**Re: Regnart Creek Trail \_ Mitigation Request**

### **City of Cupertino** **Regnart Creek Trail**

### **Valley Water (VW)** **Regnart Creek Environmental and PS&E Meeting #11**

## Project Map

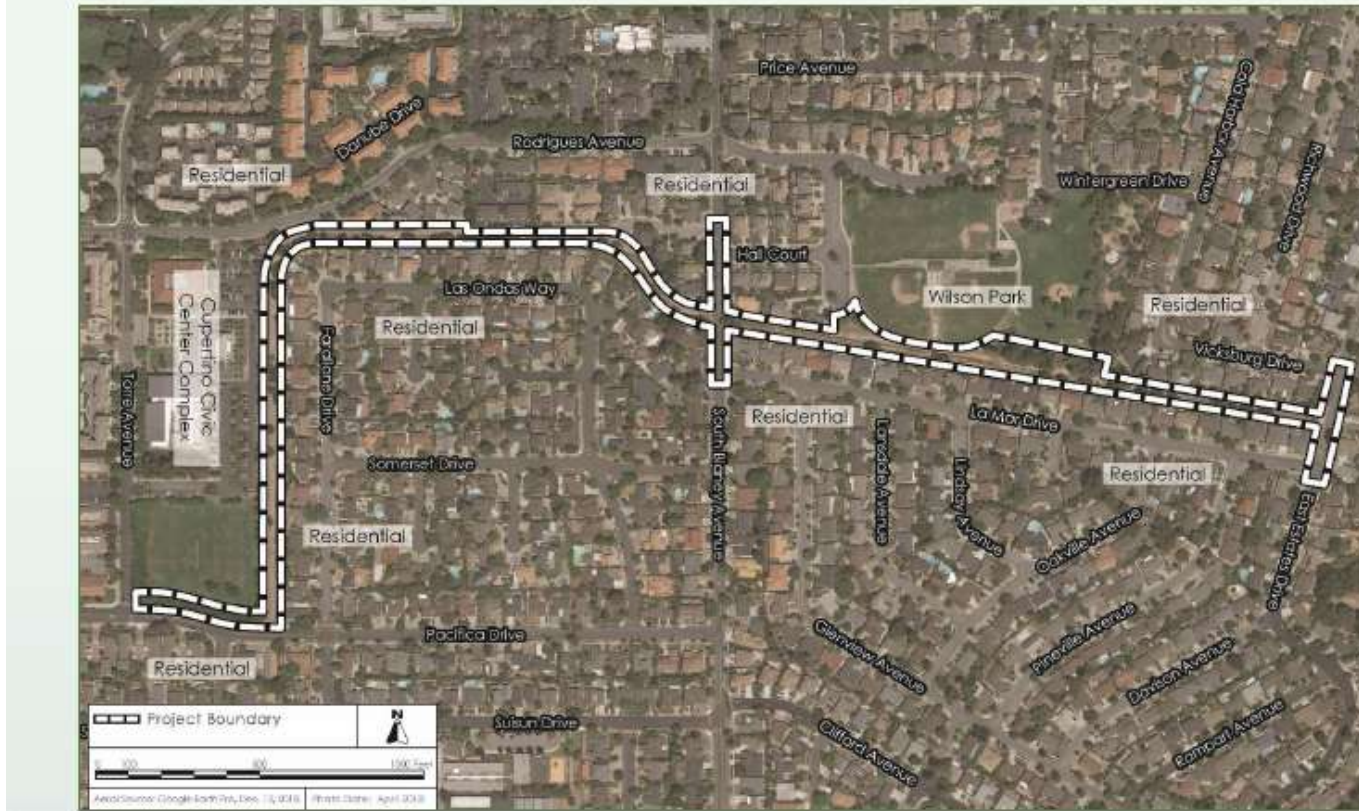
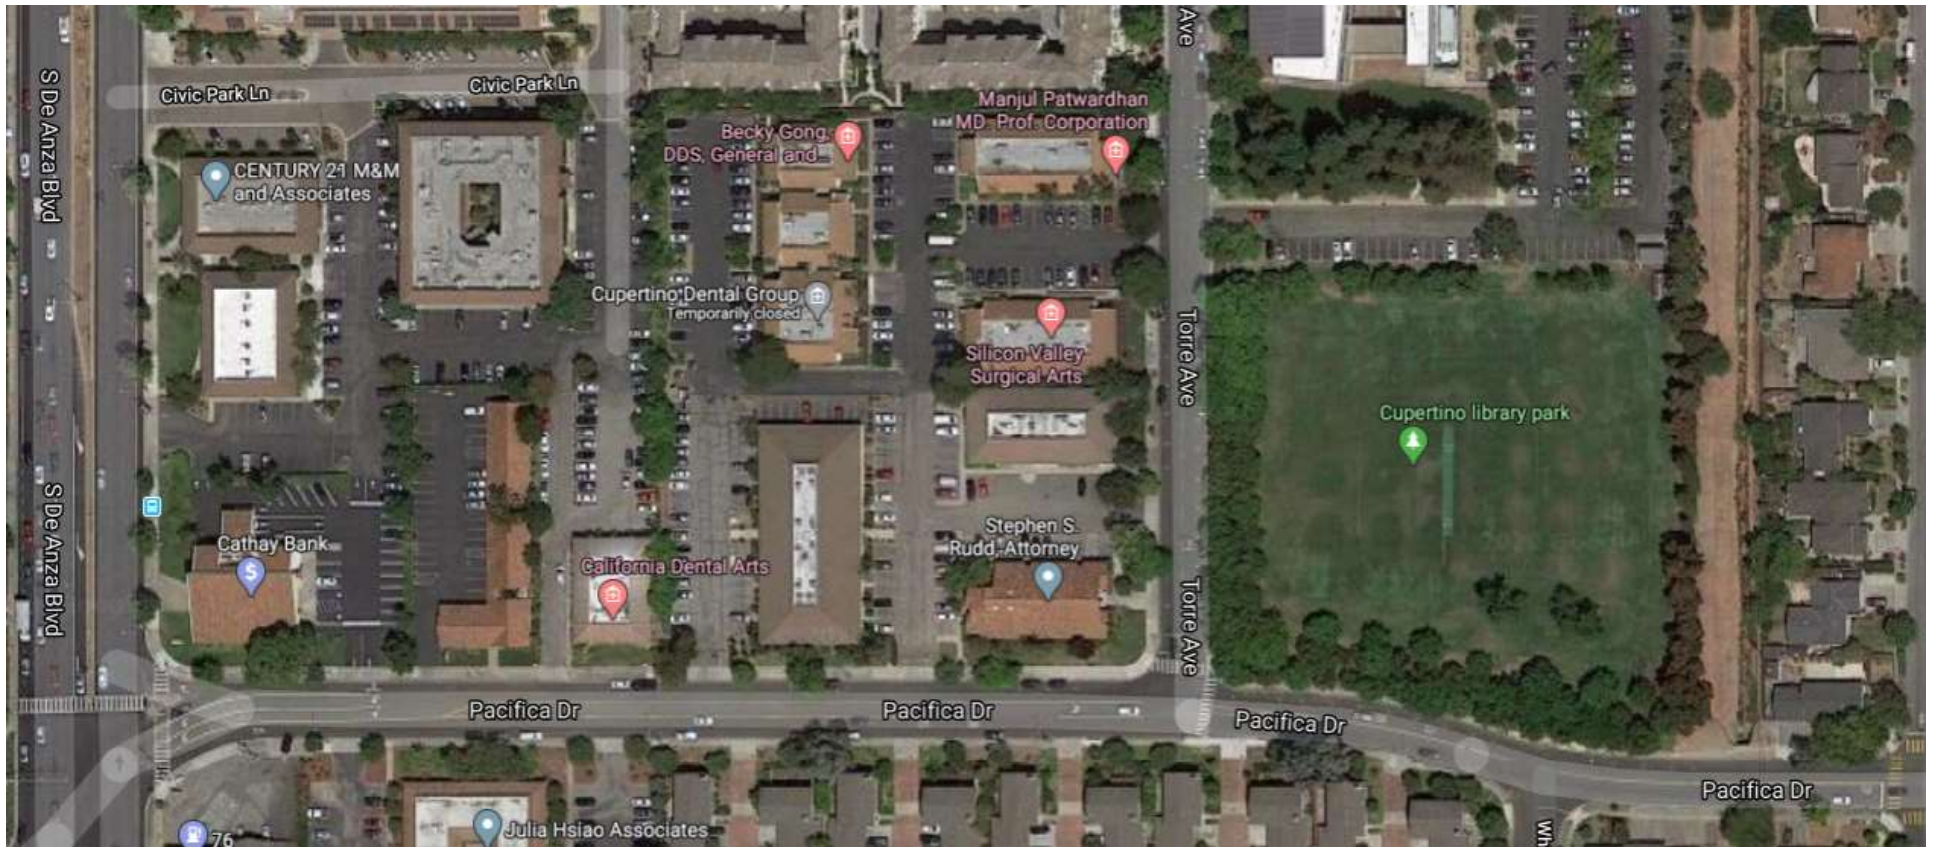
I request that the Regnart Creek Trail be modified to MOVE the section of the path along the south side of the Cupertino Library field to be along the south side of Pacifica Ave. This would require cyclists ride along Pacifica to make a clean left turn directly onto the trail along the east side of the Cupertino Library field.

- Pedestrians crossing Torre Ave.
- Cars turning left and right off of Torre Ave. because it would reduce the number of “things” happening at this intersection.
- Cars driving on Pacifica because they would not have to watch for turning cars, pedestrians AND bikes doing a left turn then sudden right turn to get onto the trail.
- A car coming from Blaney Ave along Pacifica that is turning right onto Torre behind a bike that plans to enter the proposed section of the trail would slam on their brakes if the bike suddenly slows to turn right onto the trail. It's not safe for both cyclist AND the motorist.

This proposed section DOES NOT MAKE SENSE! Cyclists coming from De Anza Blvd are already on the right side of the street. Having them turn left further down makes it much clearer what the cyclists intends to do.

NOTE: Removing the section of the trail starting at Torre Ave along Pacifica Ave would

- Eliminate the need to remove magnificent trees on the south side of the Library Park field
- Eliminate the reduction of the size of the Library Park field which is one of the few parks on the East Side of Cupertino!
- Improve bike safety because it eliminates the need for a cyclist coming from De Anza Blvd to do a left turn followed by an immediate right to get on the field.
- Improves pedestrian safety because it reduces the things happening at the intersection of Torre and Pacifica i.e. pedestrians crossing, cars turning in all directions.
